Docket No. 217 - Development and Management Plan Inspection

Northeast Utilities Service Company Certificate of Environmental Compatibility and Public Need for the construction of a 345-kV electric transmission line and reconstruction of an existing 115-kV electric transmission line between Connecticut Light and Power Company's Plumtree Substation in Bethel, through the towns of Redding, Weston, and Wilton, and to the Norwalk Substation in Norwalk, Connecticut.

Norwalk Substation

Location: Norwalk Substation Expansion

(Plumtree Substation): Photo shows a current views of the yard. 9/7/06

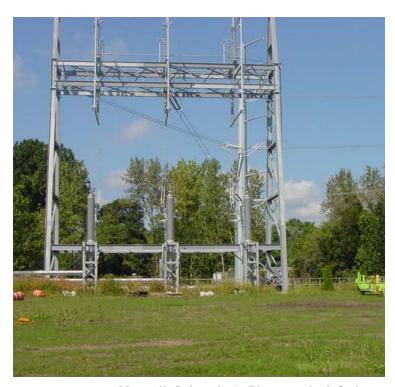
Areas of Inspection	Observation	Recommended Action	Corrected Action
Access Roads	- Work continues in the substation so the drive is again in use for this equipment. 9/7/06.	- None at this time. 9/7/06.	-N/A.

Areas of Inspection	Observation	Recommended Action	Corrected Action
	-Sediment had been noted in the wetland swales adjacent to the access road. 7/5-9/7/06	- This is likely a pre- existing condition and not directly related to the expansion work. However, if the road can be further stabilized, this may help the situation. 7/19-9/7/06	- Needs evaluation
Foundation construction	- Most major site work is complete. Remaining activities involve electrical testing and switching. 9/7/06.	- Remain aware that the perimeter of the yard is surrounded by wetlands. See erosion control section. 3/15-9/7/06.	-N/A at this time.
Erosion and Sediment Controls (includes inspection within 24 hours of a storm event)	- The site has been graded on an even level to the perimeter stone berm towards the rear of the site. 7/19-9/7/06	- The berm must remain maintained as sediment control. It may need to be built up with stone in order to filter effectively. 7/19-9/7/06	- Needs evaluation

-A few stockpiles remain but are mostly contained to the site. 9/7/06.	-Continue to monitor. 9/7/06.	-N/A
Inland Wetland and Watercourse encroachment and mitigation	- Wetlands are located around the outskirts of the substation yard. 9/7/06	- Maintain perimeter berm. Vegetation adjacent to the yard is thick and helps filter run-off. 9/7/06.	N/A.
State species of concern, threatened and endangered species	- The wood turtle was seen along the outside perimeter of the station the week of 5/25/06.	- Move machinery carefully and perform daily walkdowns of the site. Continue to watch carefully for the turtle. 5/25-9/7/06.	-Crews should remain aware during work.
Vegetative clearing limits (including trees to save or danger trees noted)	- No vegetation outside of the substation yard will need to be cleared during the expansion work.	- None (minor clearing for access for a separate project occurred outside of the yard in the adjacent ROW)	-N/A
